ADDENDA #1

RFB-2021-40

SCHENECTADY COUNTY RECORDS MANAGEMENT SHELViNG UNITS

Figure 1: Fire Rated Partition: Reference from Records Management Expansion Drawings

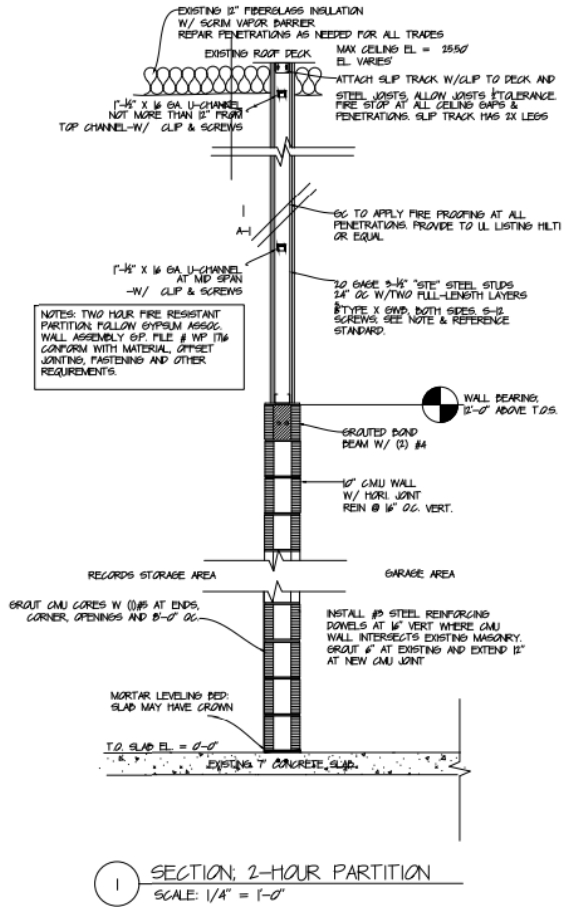
Will you require wall anchors for the units against a wall. If yes, please specify quantities of units to be secured in this manner.

- a. We recommend two anchors per unit on every 3rd unit against a wall.
- b. Advise if the walls are concrete or sheetrock. If sheetrock can you add blocking to the walls?

The walls are concrete masonry fire rated partitions, not sheet rock so add blocking it not needed. Please see Figure 1 below. Anchoring to the walls would be fine with two anchors per unit on every 3rd unit against the wall.
